DESIGN REVIEW COMMISSION AGENDA

Tuesday, September 19, 2023 – 6:30 P.M.

City of Bartlett, Tennessee Design Review Commission Staff Report

SUBJECT: Site Plan Application Review

PROPOSED EAST ELEVATION

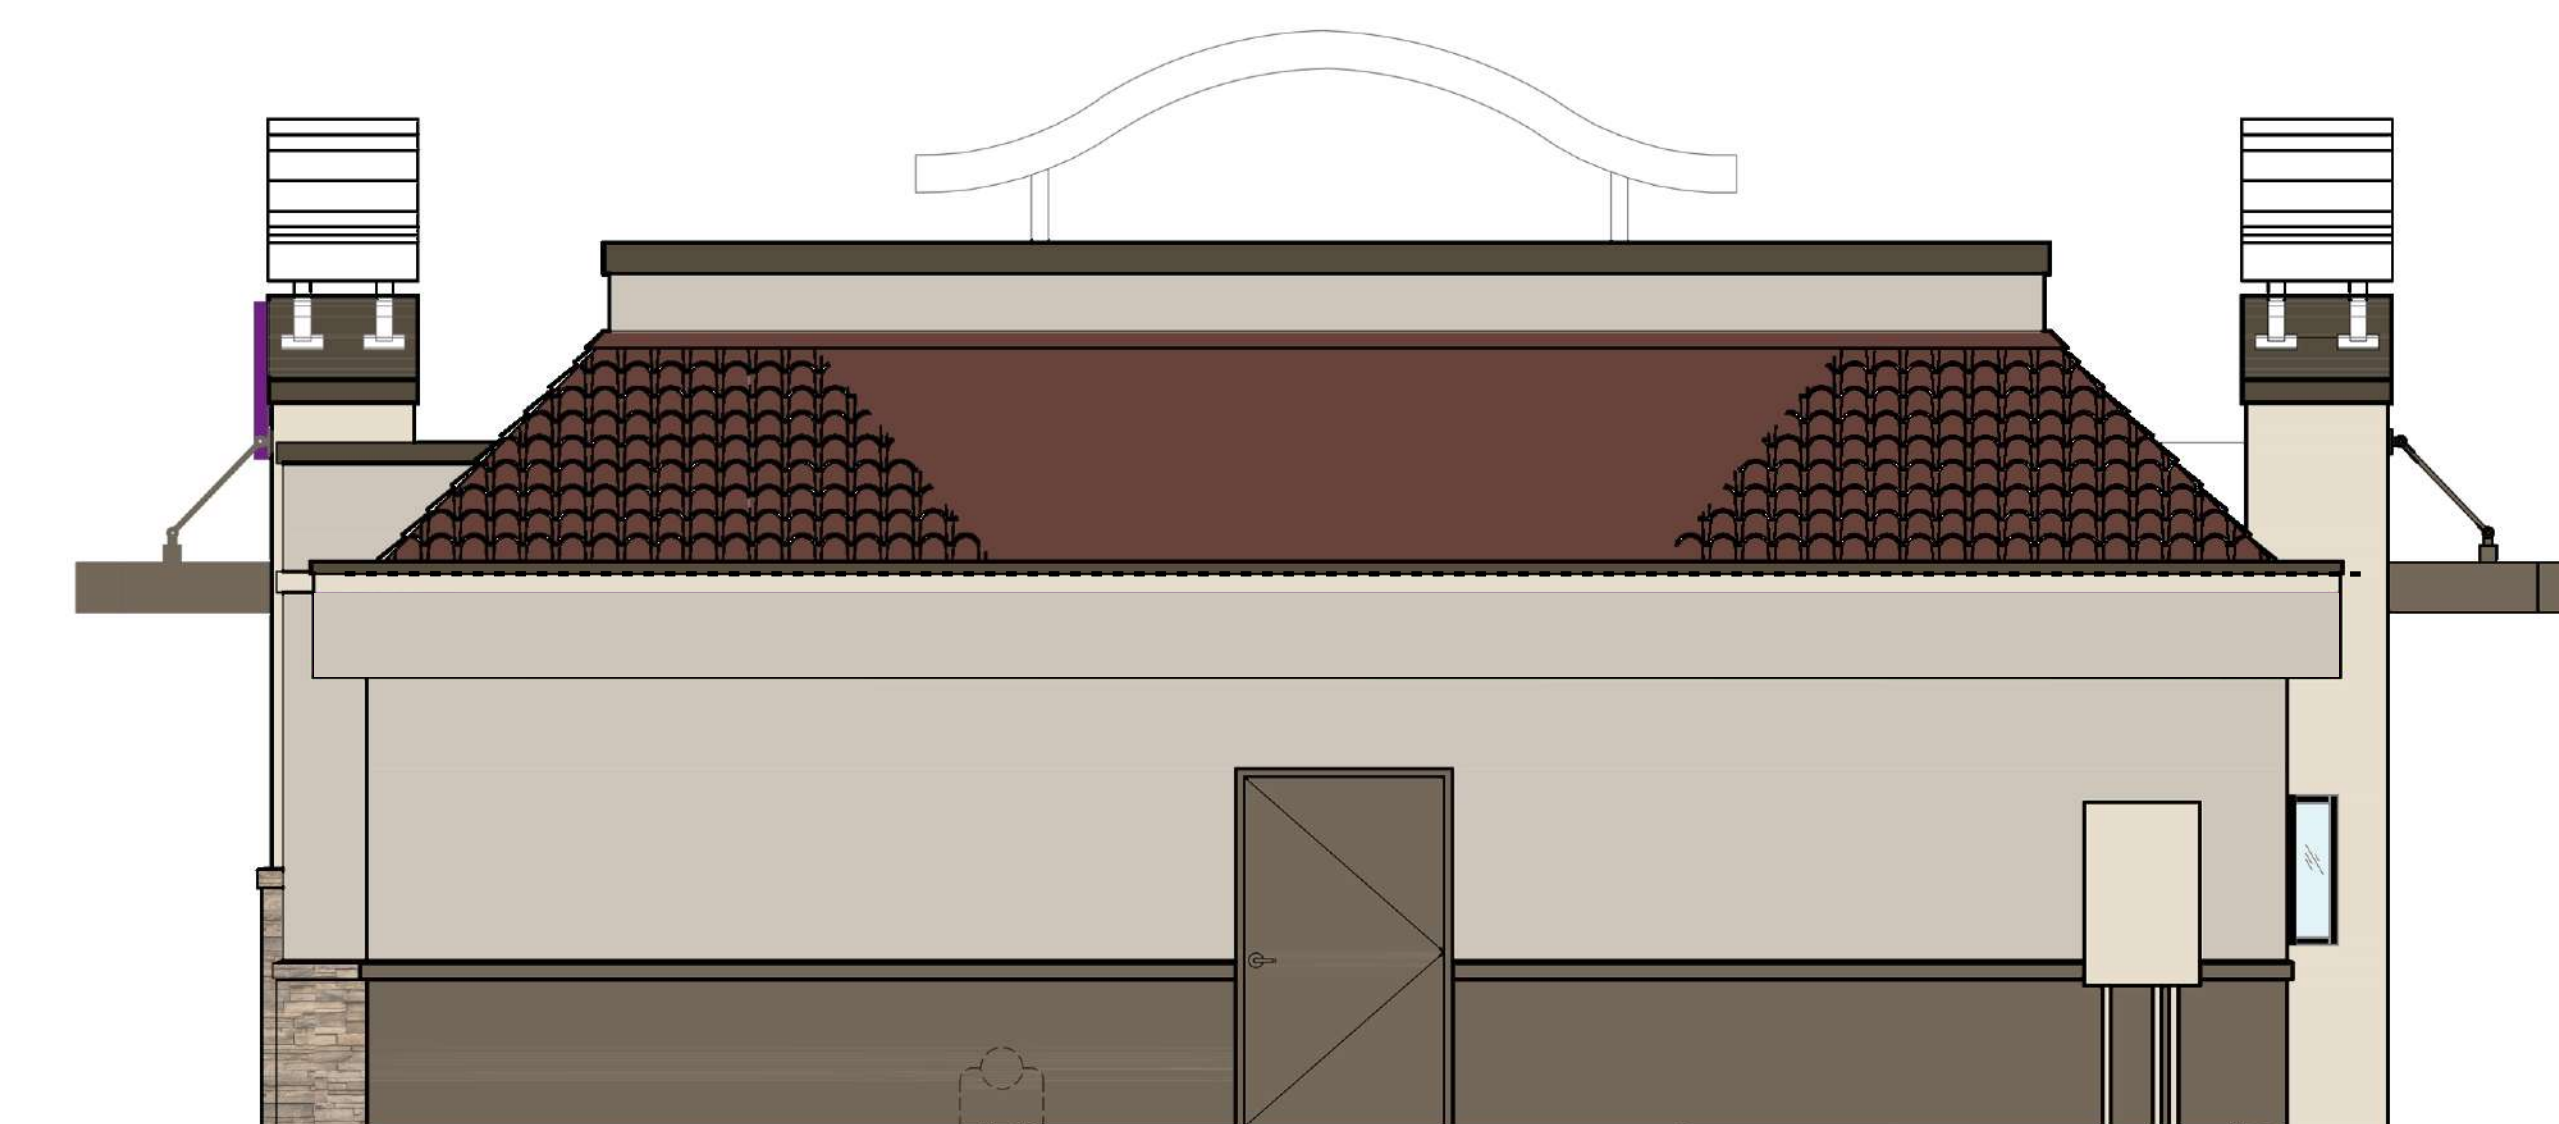
The DRC approved a revised Site Plan March 21, 2023, for façade changes, landscaping, parking lot restriping and lighting changes with the exception of the Purple SW #TB2603C band. The Commission requested Mr. McCracken return with revised elevations showing less Purple SW #TB2603C.

The front elevation faces south toward Stage Road, and the north, east, and west elevations face a shopping center parking lot. All four elevations are EFIS (Worldly Gray SW#7043, Brainstorm Bronze SW#7033), with existing dry stacked fieldstone accents. A mock canopy with EFIS (Aged White SW#9180) and field stone accents are on the front and east elevations. The upper and middle parapet will be painted in Worldly Gray SW#7043. The trim on the parapet will be painted Aged White SW9180. The accent band on all four elevations will be painted Purple SW #TB2603C. The continuous parapet caps for the upper and middle parapets will be painted in Enduring Bronze SW7055.

The existing towers at the main entrance on the south elevation, at secondary entrance on the east elevation, and the drive thru window on the west elevation will be repainted Aged White SW#9180. The metal canopies over the entrances and drive thru window will be painted Urbane Bronze SW#7048. The internally illuminated flying arch above the towers will remain the same.

1. All proposed signage shall be submitted on a separate application to the Design Review Commission.
2. The owner/applicant shall identify all utilities on site by contacting Tennessee One Call at 811 before commencing any site work.
3. It is recommended that the owner/applicant attend the meeting in order to make decisions relative to any changes that may be suggested by the DRC.

SHEET : A300

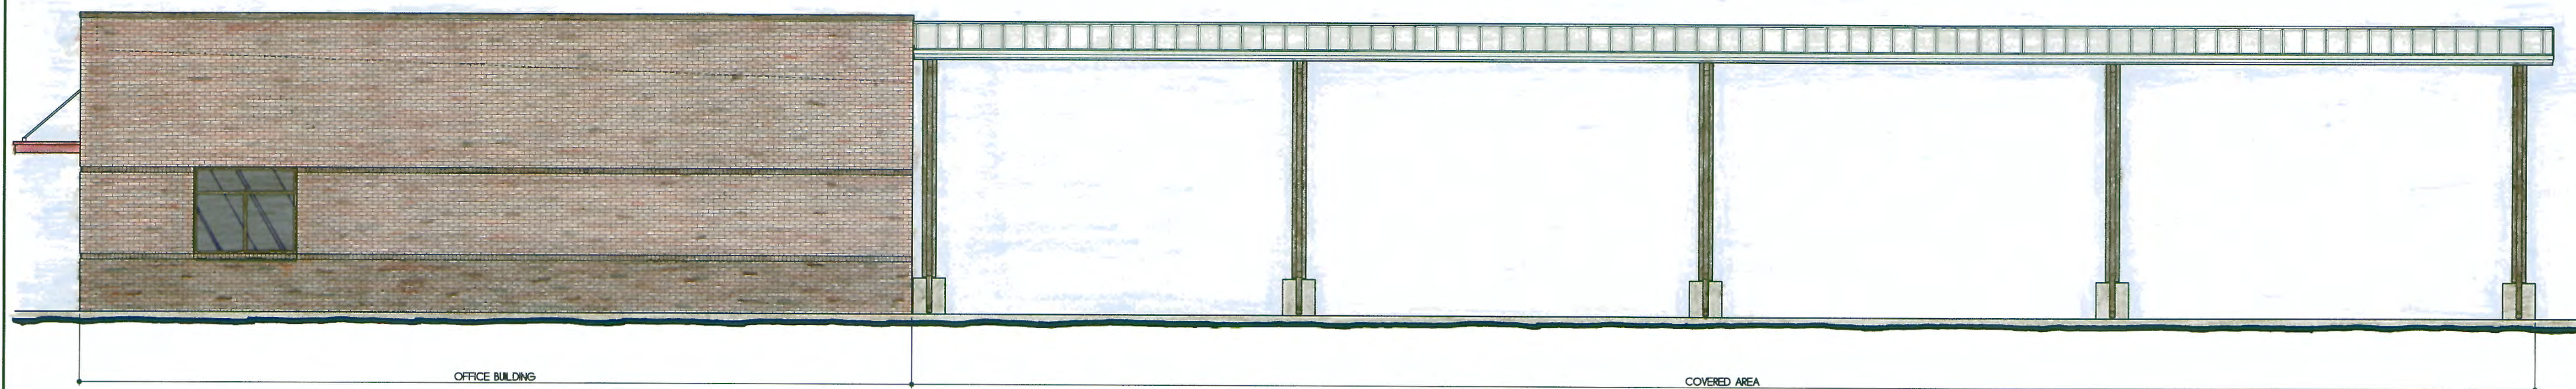
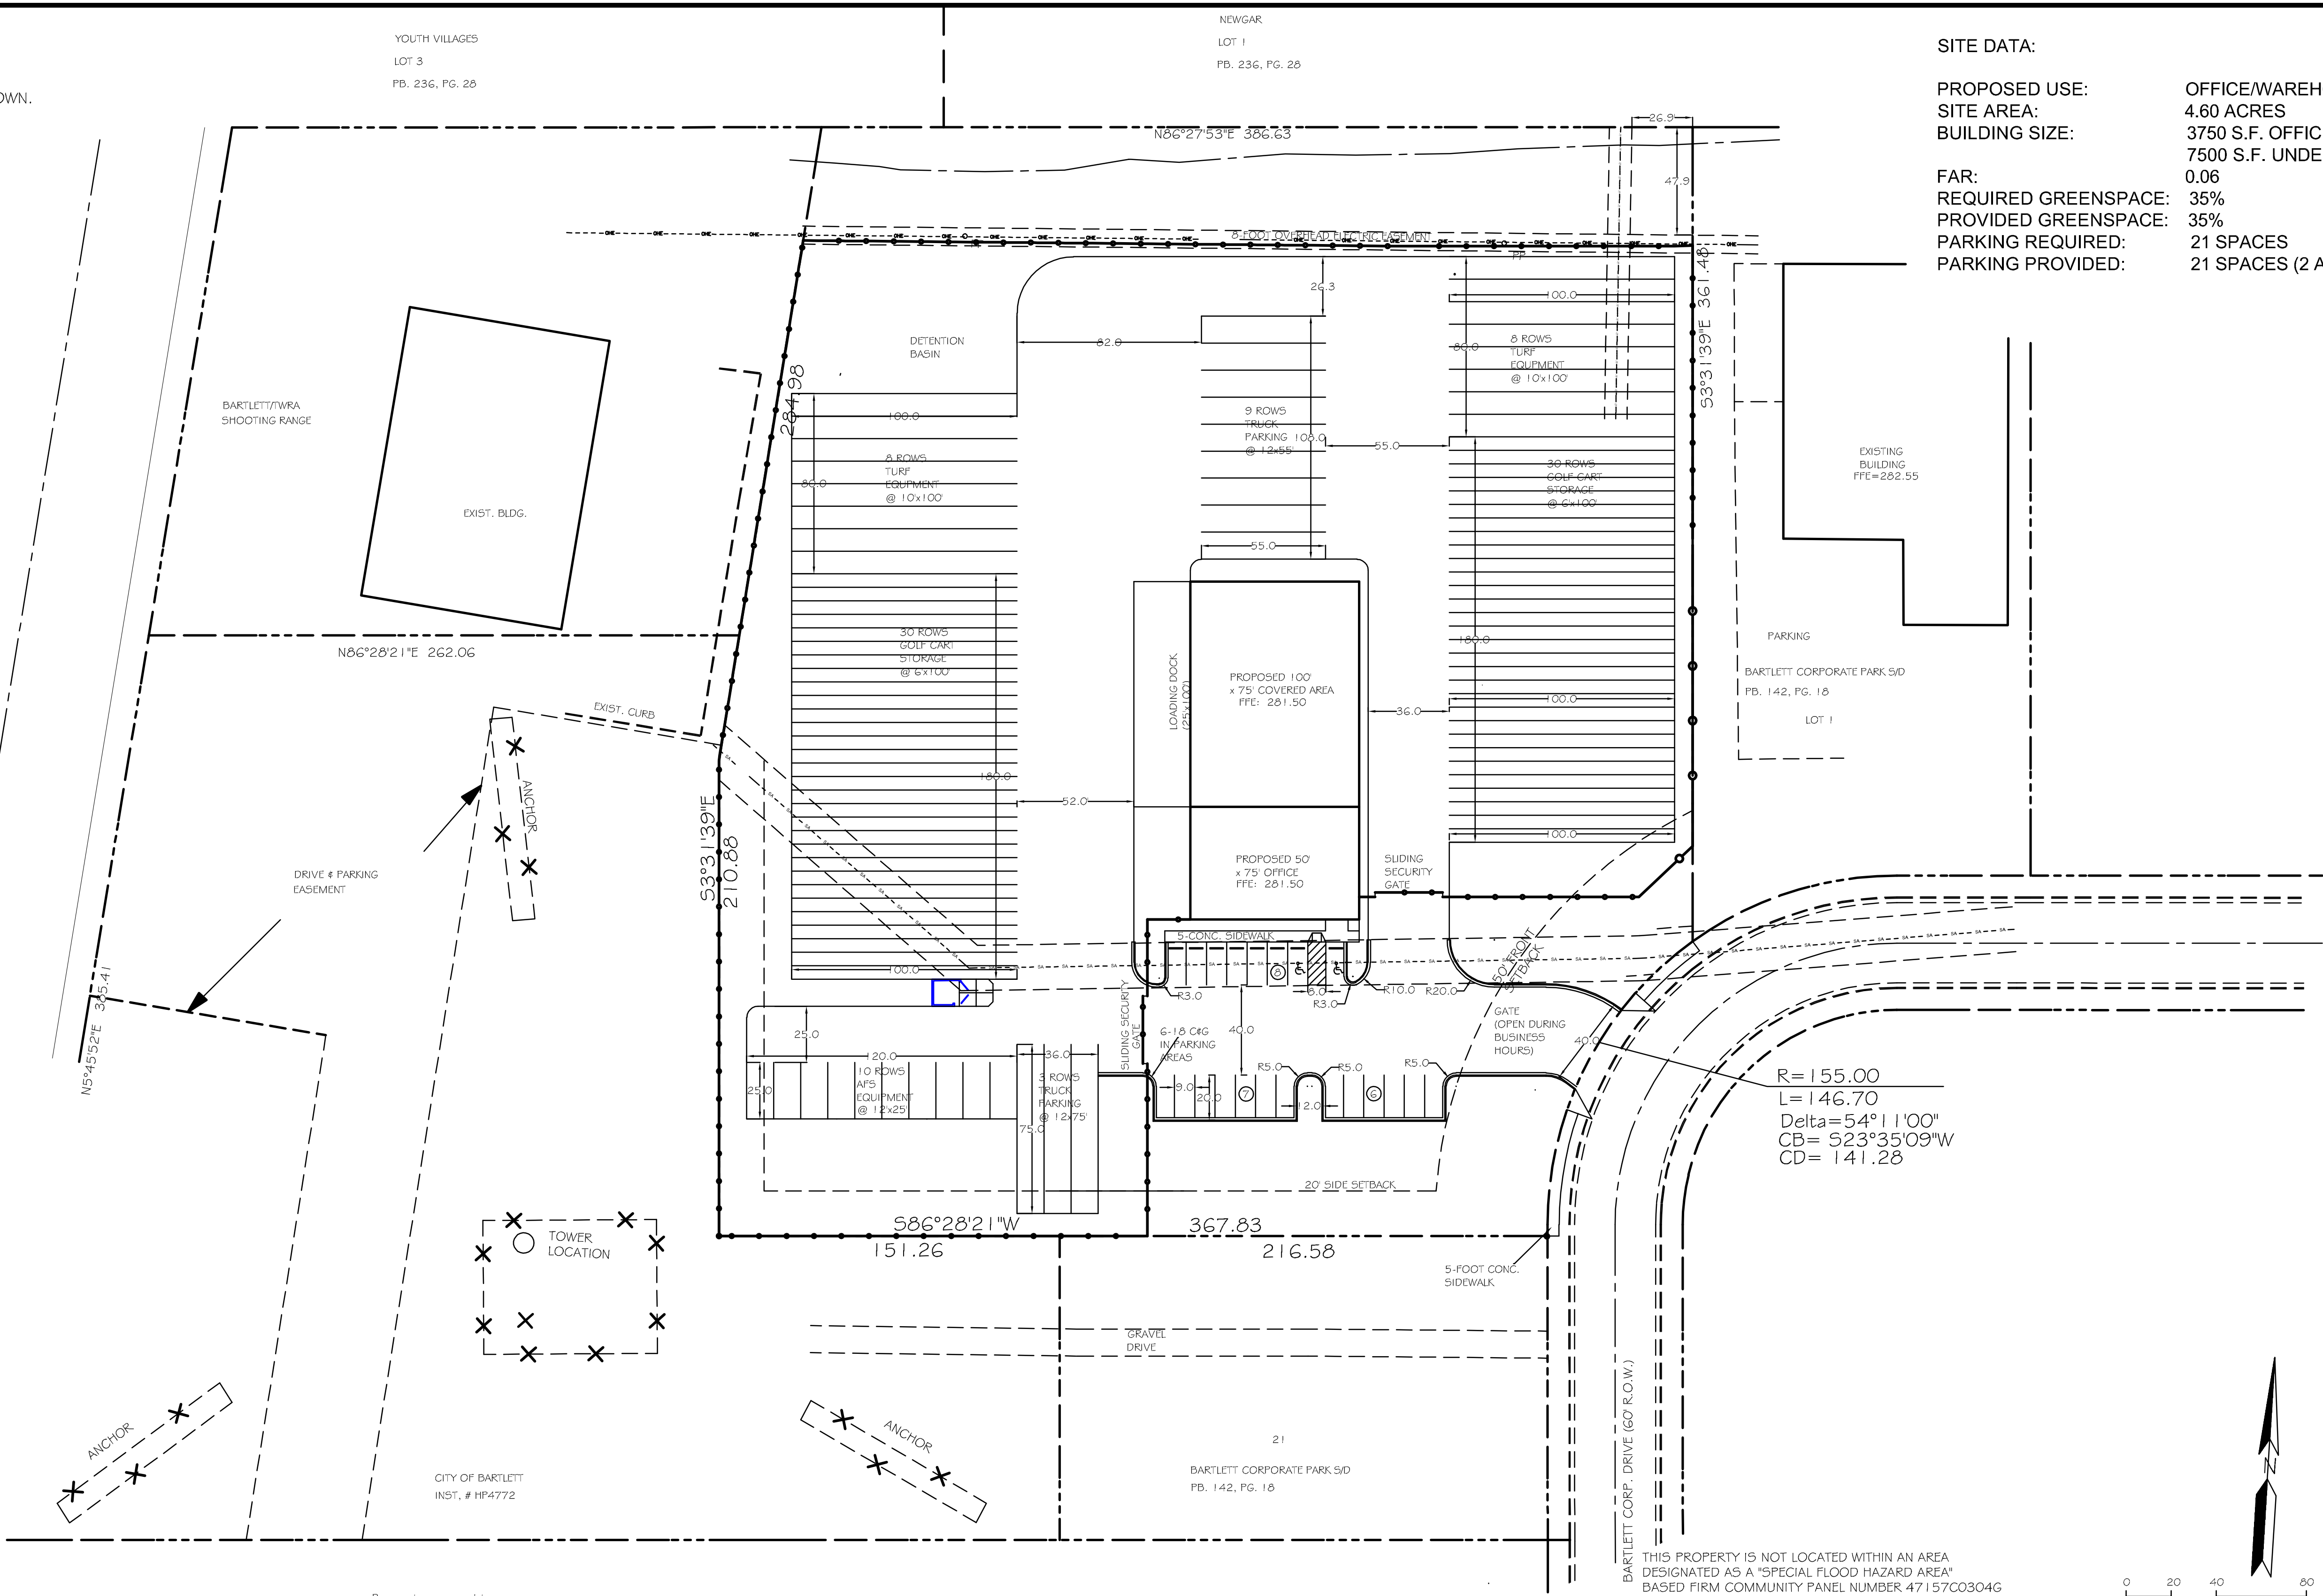
The front of the office building is the south elevation and is where the main entrance to the building is located. The north elevation of the office is attached to a 7,500 square foot covered open warehouse space.

The proposed front and side elevations of the office will be brick. The water table and two rowlock stripes consist of Triangle Brick "Williamsburg" while the upper portion of the wall will be Triangle Brick "Bessemer Gray." A dark bronze parapet coping will be at the top of the wall. The main entrance and office windows will have a Dark Bronze anodized aluminum frame with bronze tinted glass on both the front and side elevations. Above the main entrance is a metal hanging rod awning in "Colonial Red". The north elevation of the office building will be Almond colored metal panels. The elevation also features two roll up doors, as well as a personnel door, which will be painted to match the Almond metal panels.

The roof of the covered open space will be an Almond colored metal standing seam roof. The roof will be supported by metal building columns painted Dark Bronze set in a reinforced concrete base. The metal gutters and trim will be Almond while the downspouts will be Dark Bronze.

1. Staff recommends the privacy slats for the chain-link fence be black vinyl.
2. The Fire Marshall will require a Knox Box padlock that will be dually coordinated with fire and police for emergency access.
3. Applicant shall provide a landscape plan showing truck parking buffer.
4. The applicant shall identify the green/open space of the site on the site plan data table.
5. Irrigation and maintenance is required for all planting on the landscape plan.
6. Applicant shall provide light pole diagram to reflect the installed light pole height will be less than the required 25 feet from top of grade.
7. The owner/applicant shall identify all utilities on site by contacting Tennessee One Call at 811 before commencing any site work.

Folding Security Gate - 6-8' x 6'

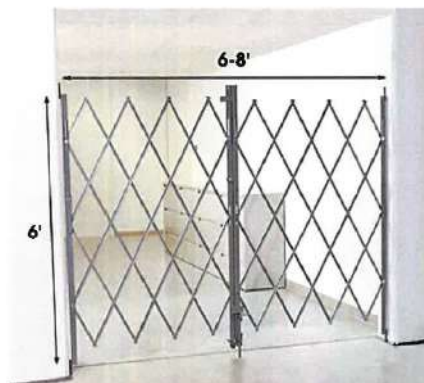
The specific request to the DRC by the applicant is for the approval of a revised building elevation to add accordion security bars behind the window frames inside the store on the front elevation of the building facing Memphis-Arlington Road. The City of Bartlett Department of Code Enforcement was notified that the applicant installed the accordion security bars in the storefront windows without obtaining DRC approval. The security bars are made of bronze aluminum to match the storefront, and they are installed by non-anchor bolted screws into the hollow aluminum window frames.

1. The storefront windows are made of insulated tempered glass. The DRC has not approved the installation of security bars in the windows since it is more of a visual deterrent than a structural deterrent.
2. The other tenants within the shopping center are not experiencing these security issues, so the aesthetics of the building would be altered to satisfy the attractive nuisance concerns of this specific use.
3. Alternative security products are available for the applicant. Those alternatives include the following:

Recommendation: Denial of the proposed security bars since alternative security products are available for the applicant.
